From: [REDACTED]
To: [David Loya](#)
Subject: Gateway Area Plan
Date: Tuesday, April 16, 2024 9:06:32 PM

From: [REDACTED]
To: [Meredith Matthews](#); [Stacy Atkins-Salazar](#); [Alex Stillman](#); [Kimberley White](#); [Sarah Schaefer](#); [Scott Davies](#); [Dan Tangney](#); [Matthew Simmons](#); [Peter Lehman](#); [Joel Yodowitz](#); [Abigail Strickland](#); [Millisa Smith](#); [David Loya](#); [Jennifer Dart](#); [Karen Diemer](#)
Subject: from Fred Weis: Gateway Code - Comments and suggestions
Date: Friday, April 19, 2024 9:38:24 AM
Attachments: [Gateway-Code-Comments_Fred-Weis_April-18-2024-v10.pdf](#)

The attached document includes my comments and suggestions for improvements to the Gateway Code. I composed this document so that we could create a better Gateway Code for Arcata.

Also known as the form-based code for the Gateway Area Plan

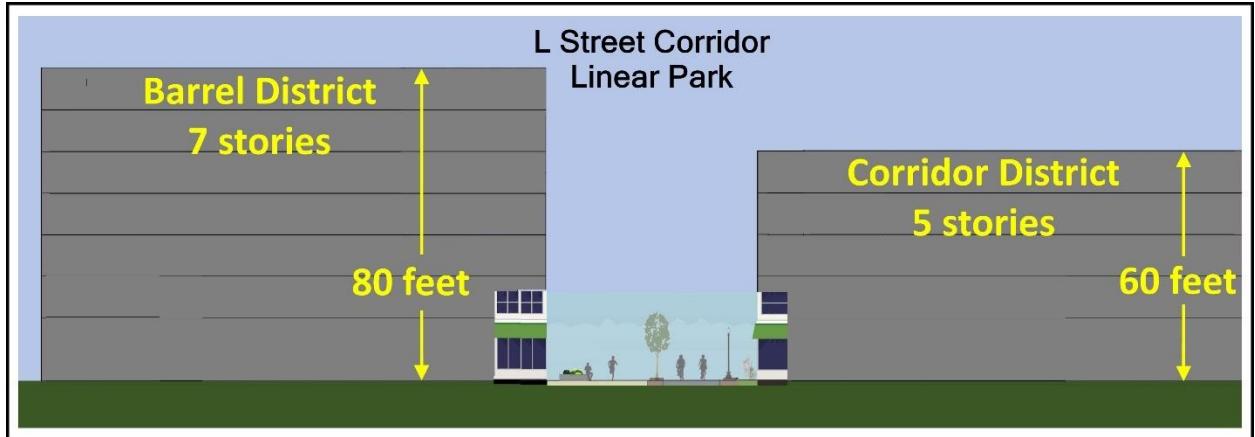
8. A building could be placed perhaps right on the property line, perhaps 10 feet inside of the property line, perhaps 15 feet inside of the property -- depending on the readers' interpretation of the code. The Planning Commission needs to clarify this.

The question is this: The L Street corridor is no longer a street. It is the location of a full-width linear park. As such, it is not a street, and therefore the "other property lines" minimum setback requirement would be used. That is: Zero feet, no setback. Since it's not a street, there would not be a requirement for sidewalks either.

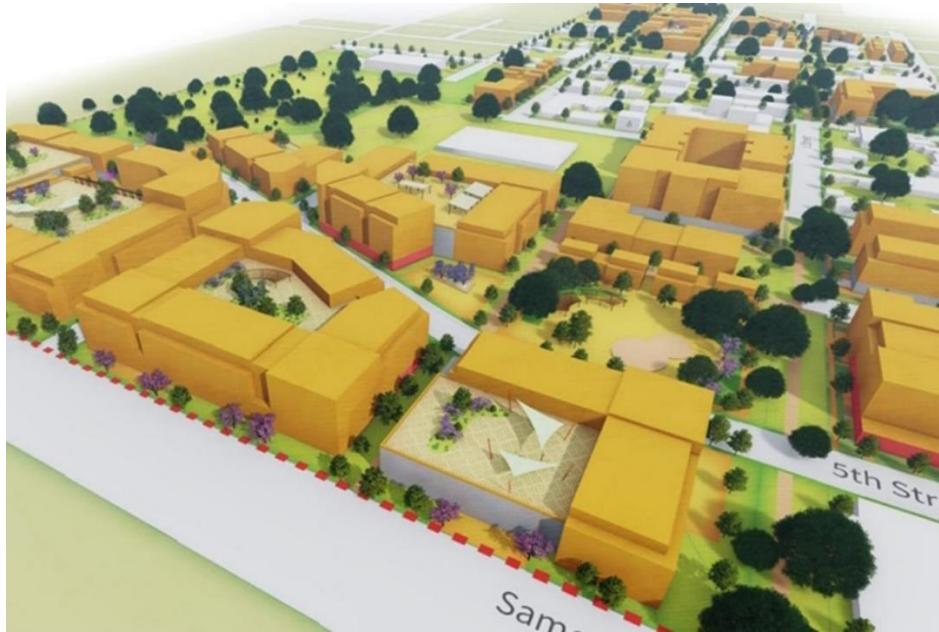
- All buildings are shown as flat roofed. Software exists to show peak-roofed buildings but the authors of this plan did not use that software. (For a more realistic 3D image, see the 3D images in the draft Environmental Impact Report, following page 3.2-26, such as Figure 3.2-2B.)

- The shadows cast from the trees appear to be longer than the shadows cast by 5 or 6-story building – which in a subtle manner makes the buildings appear less tall.

- There are not horizontal lines to show us the number of stories of the buildings in these images. A few buildings have red-colored ground floors, and from this it seems that the buildings in the Barrel district are five stories in height – the same height as the buildings on K Street in the Corridor district, and two floors lower than the seven-story maximum height of buildings in the Barrel district. **If that is the case, this really is not an image of a “Potential New Development” build-out.**

Figure 2-54: Pedestrian Realm Dimensions

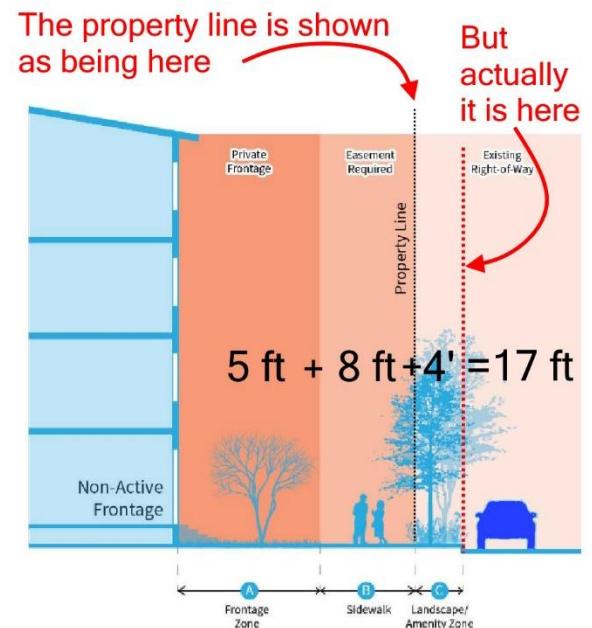
1. **The “Figure 2-54: Pedestrian Realm Dimensions” drawing appears to have been a hold-over from the first draft of the Gateway Code.** That draft showed a pedestrian realm total distance of **28 feet** for non-active frontage – that is, a building would be set back 28 feet from the street curb. This would not be a workable distance in Arcata, and so it was reduced. The image that is in this is not a correct image for the dimensions of this Gateway Code.

- The image has the property line in the wrong position. As shown, the property line is 4 feet from the curb. In Arcata, the property line is at the curb.
- This is for a “non-active frontage” – such as an apartment

building. It shows the building as set back 17 feet from the street. The theoretical minimum setback of 10 feet that's in the District Standards section of the Gateway Code would not be possible.

Figure 2-53: Pedestrian Realm

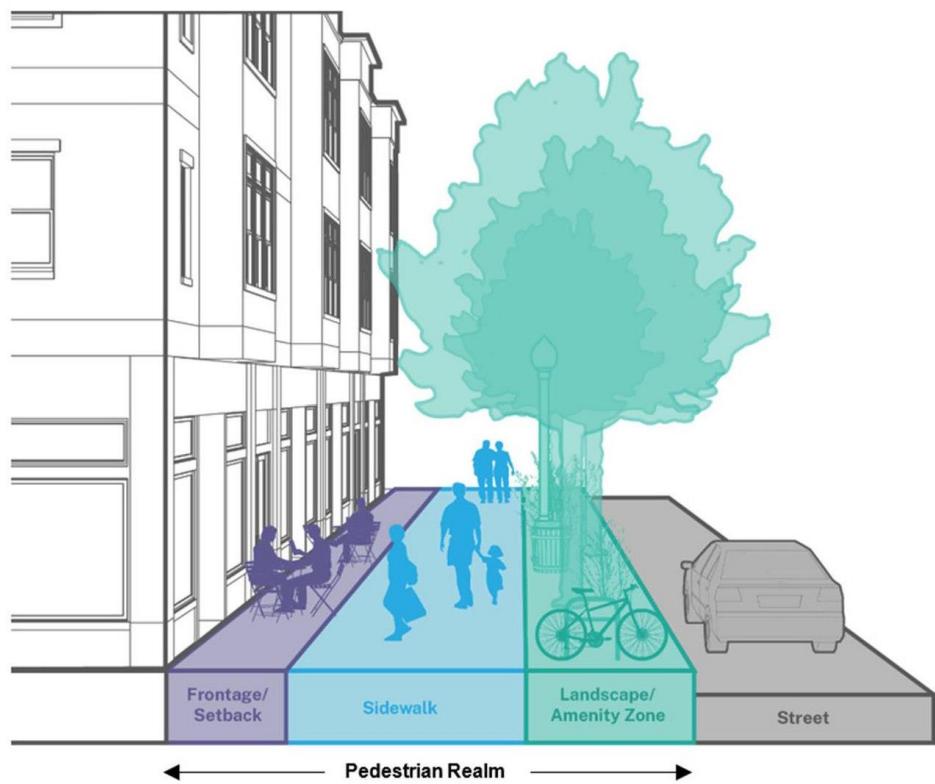
2. Here is another misleading image, from page 45. It also appears to have been prepared for a city other than Arcata. The dimensions here are for an “active frontage” building, with stores, shops, restaurants occupying spaces on the ground floor.

3. We can note that, just as with a sidewalk in front of a standard house in Arcata, the “Landscape / Amenity Zone (4 feet wide) and the Sidewalk (8 feet wide) are permanent easements that are “taken” by the City for public use, yet the property owner is responsible for the construction and maintenance. The street trees, bicycle racks, trash receptacles, and any planters, benches, or seating are installed by the property owner. Typically the City has its employees responsible for maintaining the trees. All of this is (except tree maintenance) is specified in the Gateway Code in this section.

Figure 2-46: Vertical Façade Breaks

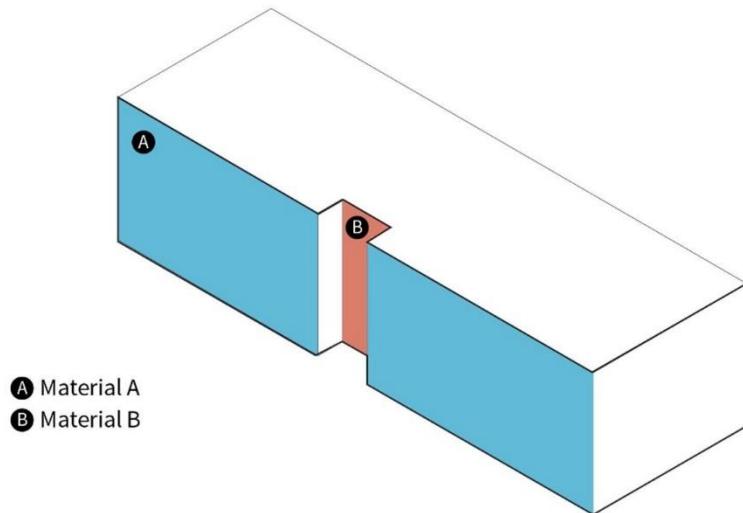
“A building 150 to 300 feet in length, which faces a public street, right-of-way, or publicly accessible path, shall include at least one vertical facade break with a minimum area greater than 64 square feet, a minimum width of 8 feet, and a minimum depth of 4 feet. See Figure 2-46.”

b. The diagram, Figure 2-46, is not a valid diagram to support this policy. It shows a break of material. It does not show a break with width and depth. This policy does not mention material.

Figure 2-56: Conceptual Greenway Configuration

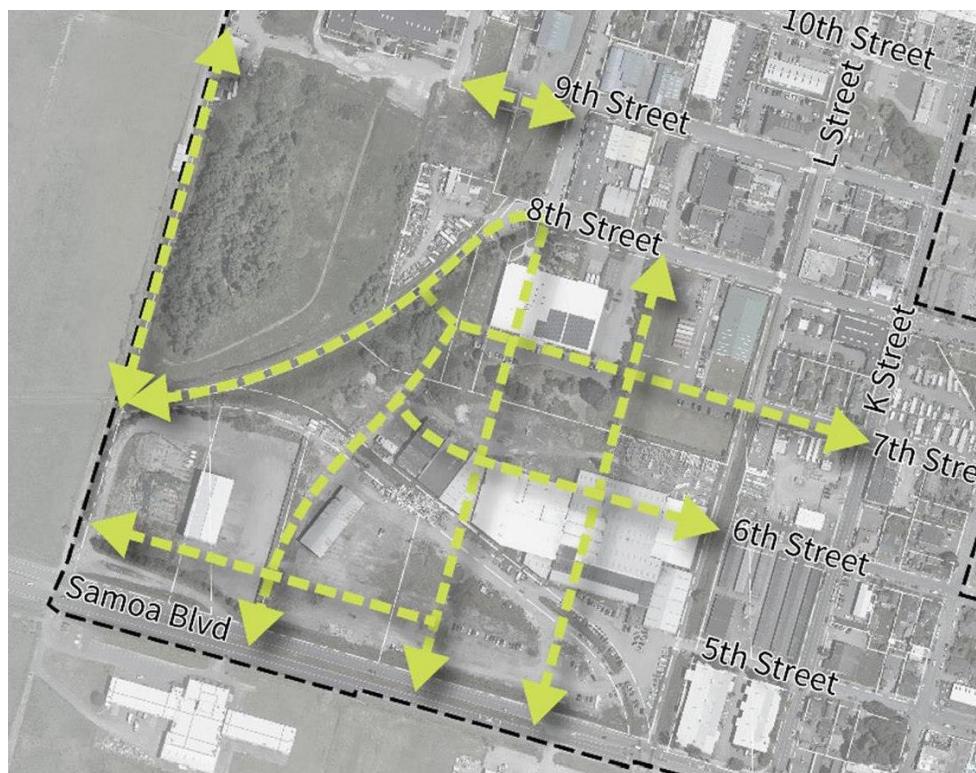
2. Here is Figure 2-56, on page 49:

3. There are a few points we can note.
 - a. The draft Gateway Code states “Greenways are required in the approximate locations shown in Figure 2-56.”
 - b. Figure 2-56 shows the Greenways going through large swatches of private property. The greenway that starts behind the Greenway building (the name is a coincidence) on where 7th Street would be, west of the L Street corridor, runs through private property. The City does not have the rights of way for this. The greenways proposed for the southern section of the Barrel district are all on private parcels.

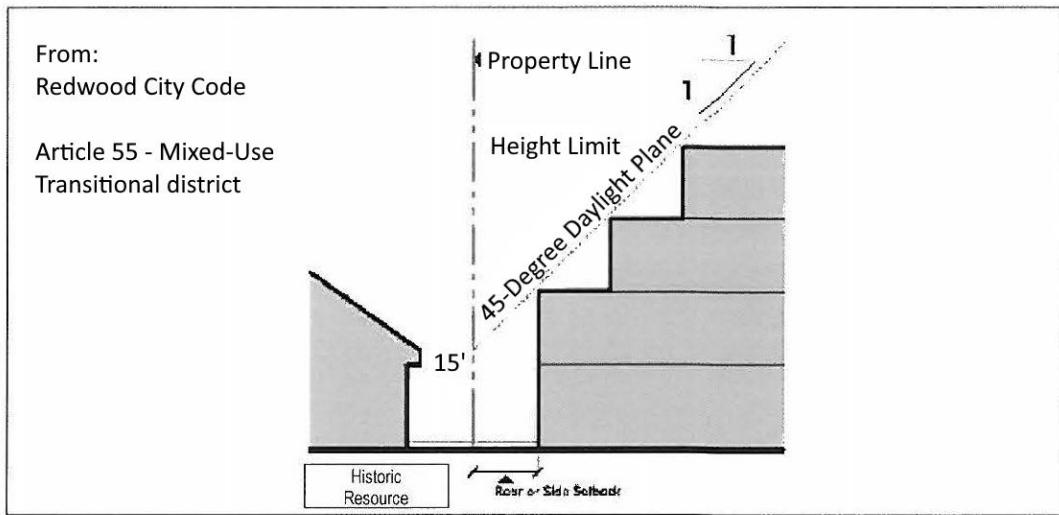
Is the Gateway Code going to allow a developer to build right up to the property line – along the L Street corridor linear park?

The question is this: The L Street corridor is no longer a street. It is the location of a full-width linear park. As such, it is not a street, and therefore the “other property lines” minimum setback requirement would be used. That is: Zero feet, no setback. Since it’s not a street, there would not be a requirement for sidewalks either.

Figure 2-36: Active Building Frontage Type Required Location

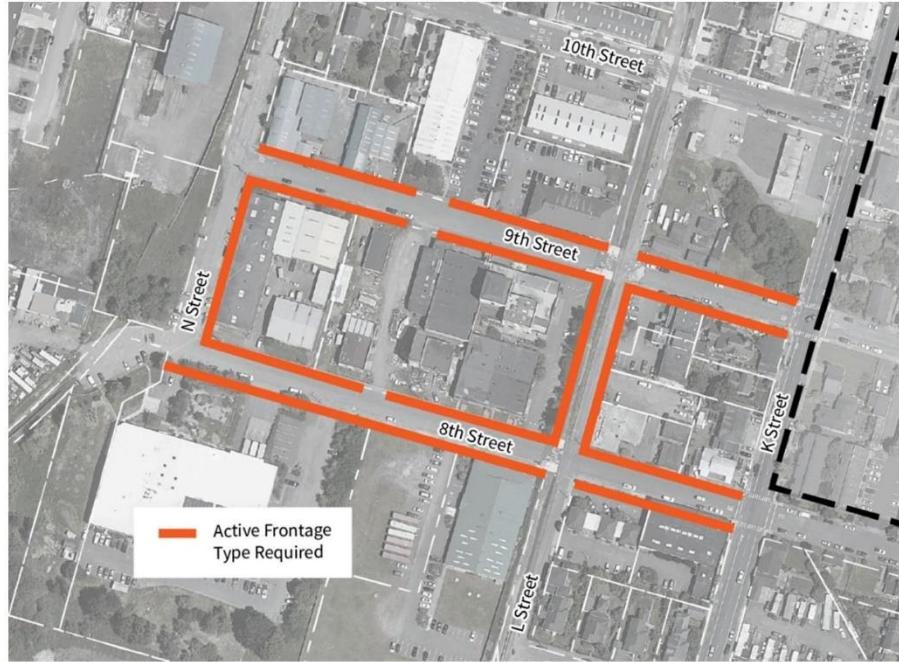
In the current draft Gateway Code, active building types are required for the area around the Creamery building: On the north and south sides of 8th and 9th Streets; on the east side (Creamery side) of N Street; and along both sides of “L Street” – which is no longer a street, as discussed. See Figure 2-36, page 25:

Suggestion: The Commissioners may wish to expand the area where Active Frontage types are required. Possibilities include:

Figure 2-58: Parking Placement

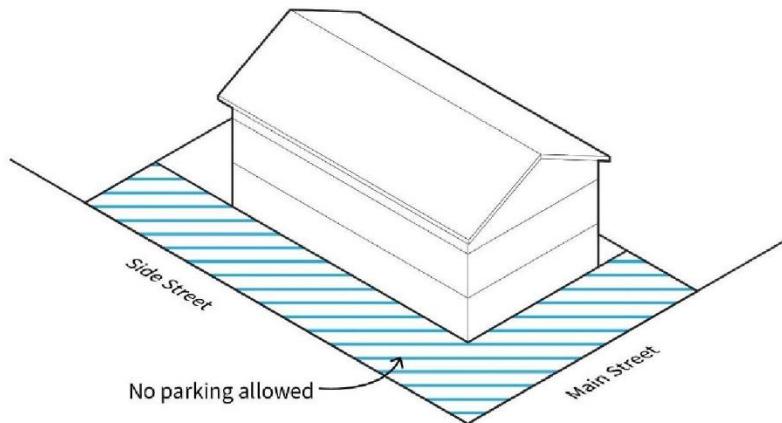
The paragraph above says: “5. Parking Placement. **Surface parking spaces may not be located** in the area between the front and street side property line and a line extended horizontally from the exterior building walls to the edges of the lot. See Figure 2-58.”

If there is no parking allowed between a building – extending to the edges of the lot – then where is the need for a fence for a parking lot that faces the street?

Figure 2-38: Enhanced Upper Story Step Back Location

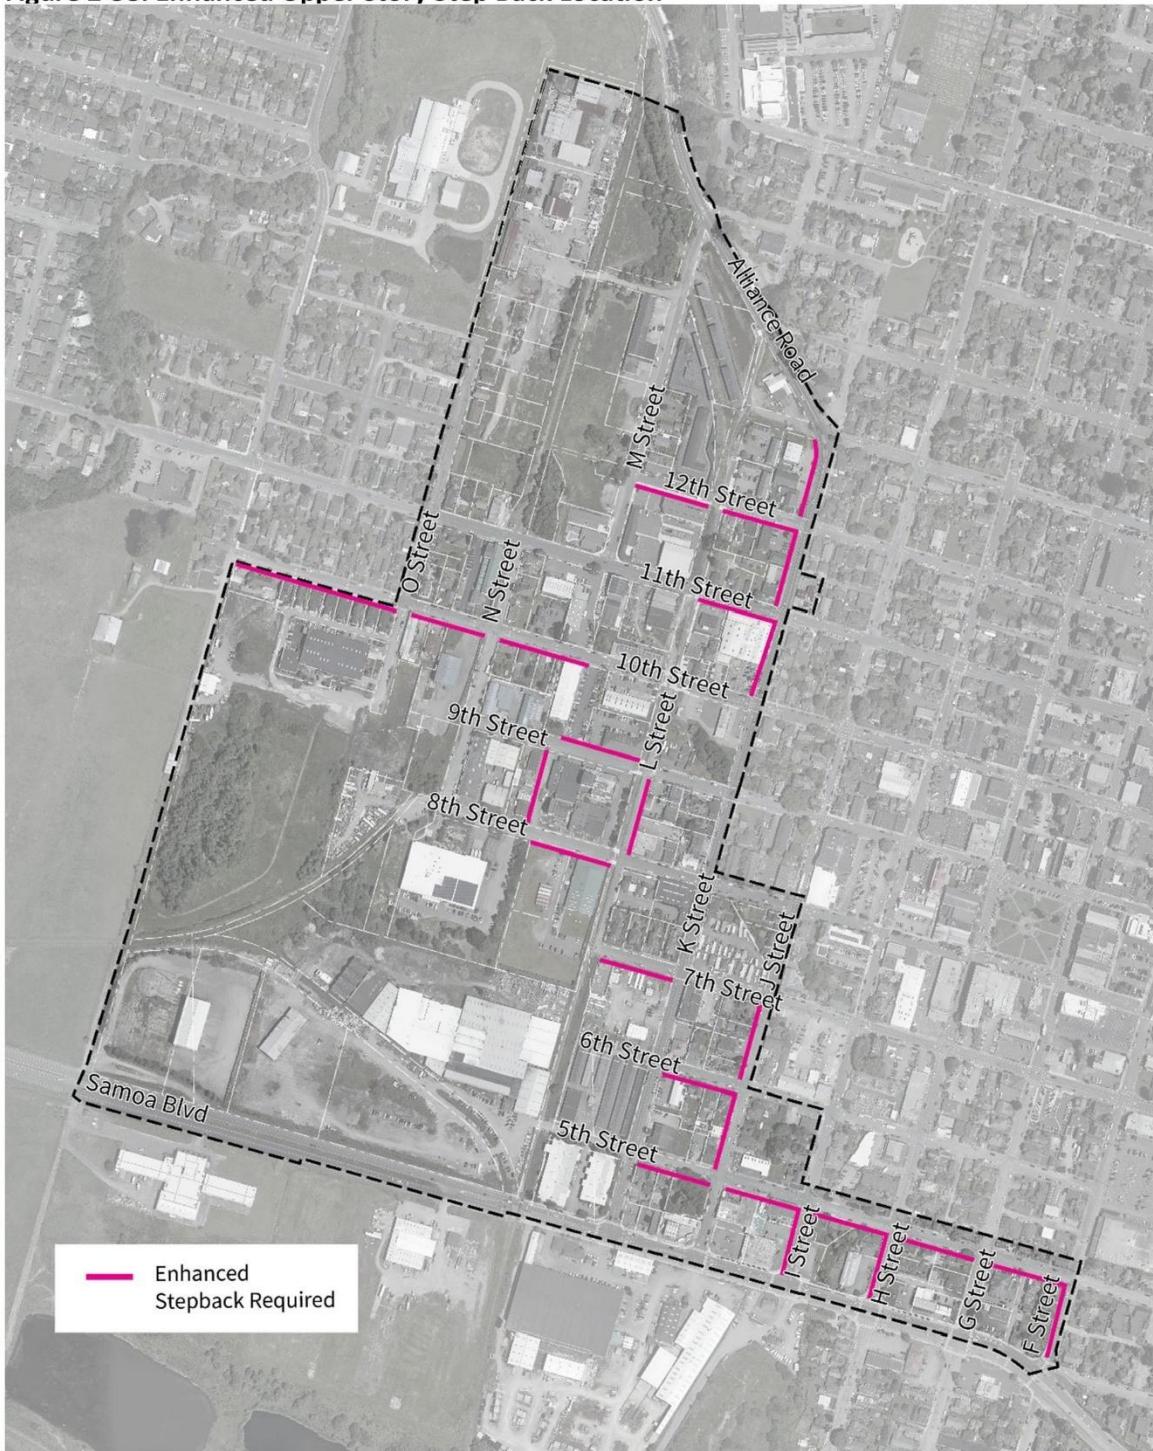
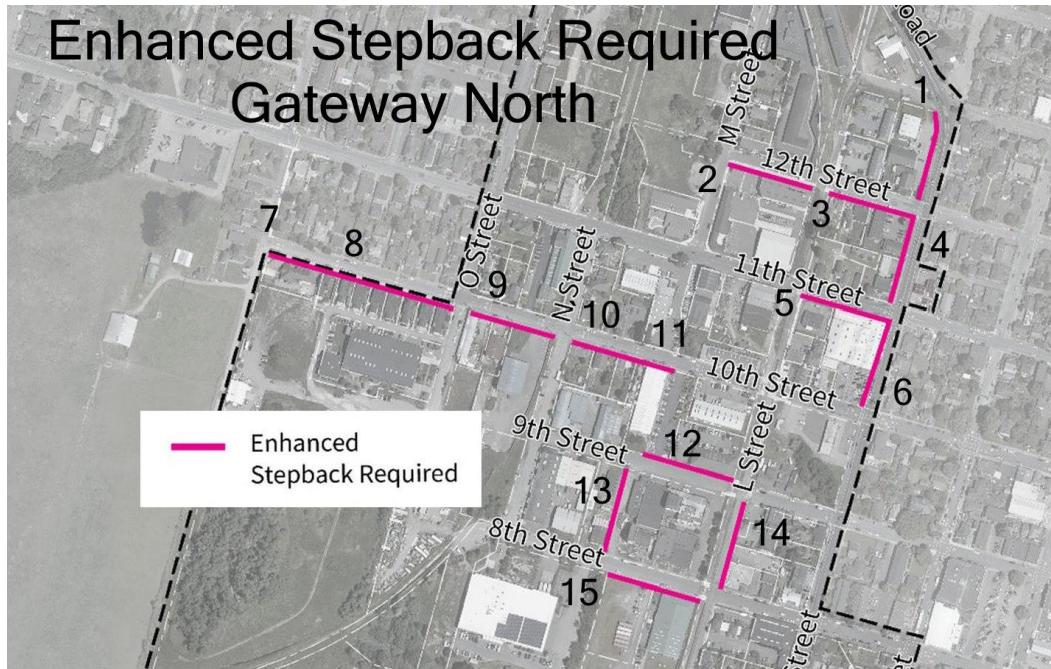
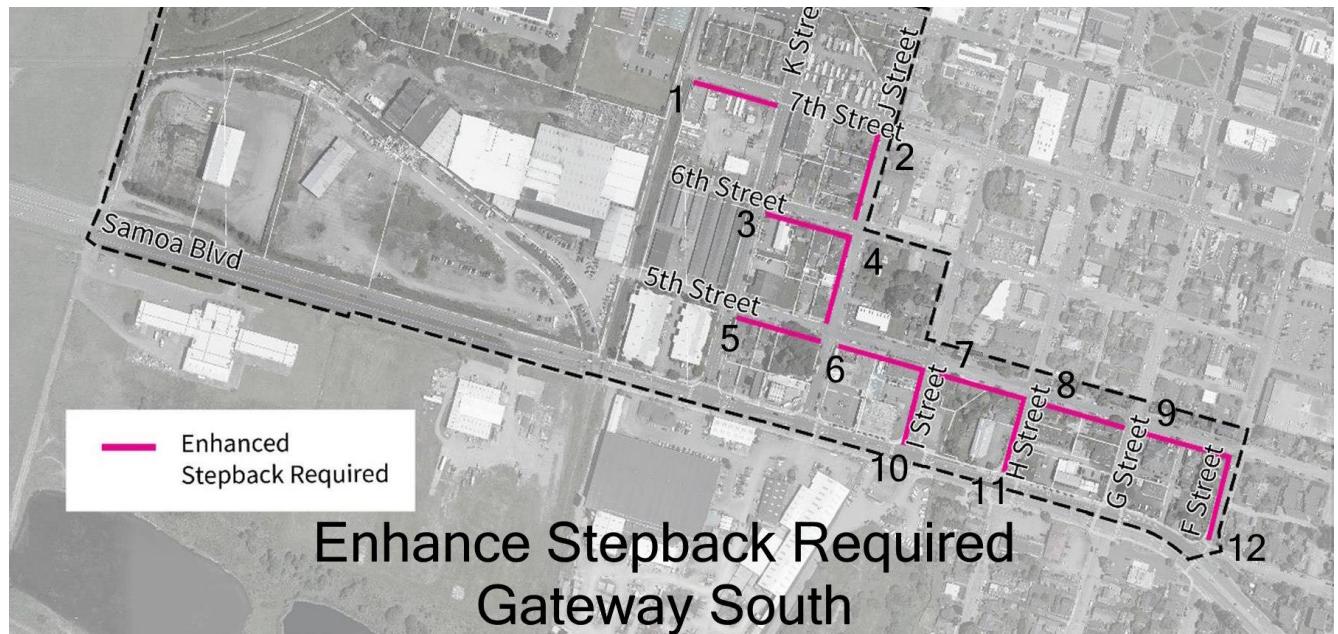
By that statement we infer that the purpose is to protect the "blue-sky" views and solar access for the occupants of existing homes and apartments located across the street – and to keep those people from feeling overwhelmed by a large-massed building just 60 or 70 feet away.

The first question that comes up when looking at this map is: How were these locations selected?

Figure 2-28: G-B District Building Massing

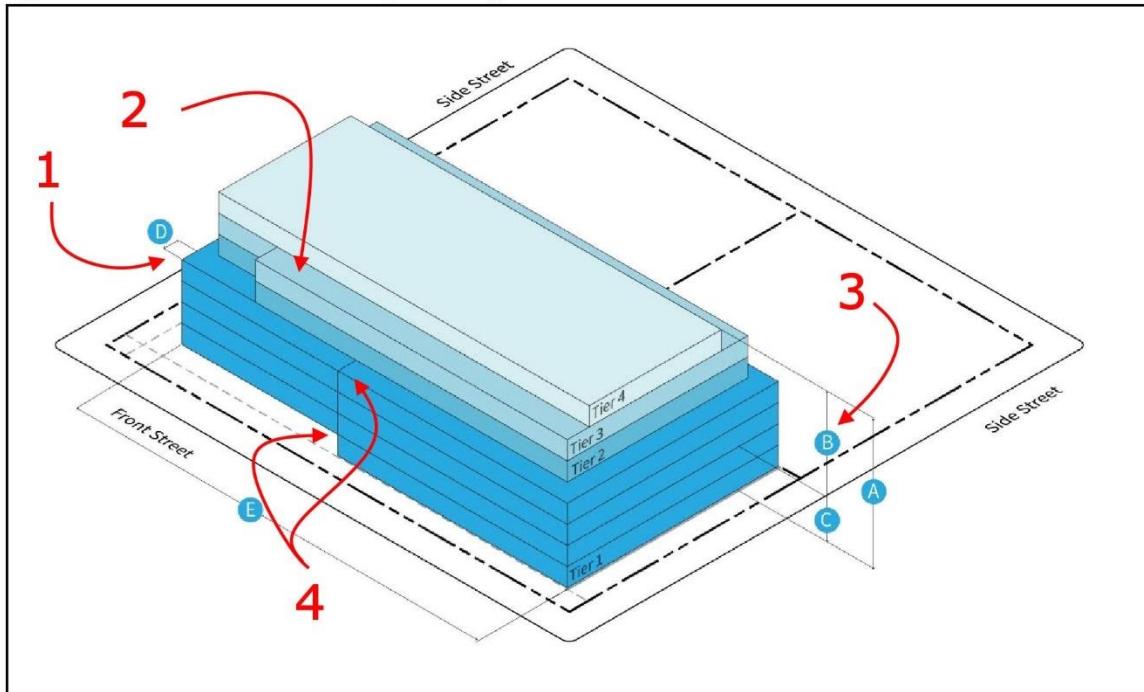
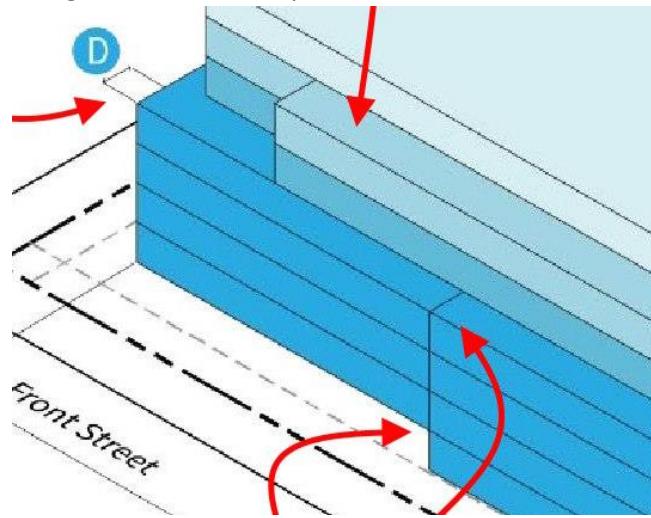
I believe these drawings should be improved. As isometric drawings that are intended to convey information, they rate a B-, or C+. This is what's wrong:

1. The width of dimension “D” does not match the width of the stepback that it’s intended to illustrate. In addition to where it is, “D” should also be placed on the portion of the building closest to the street – as that’s the focus of the upper-floor stepback.
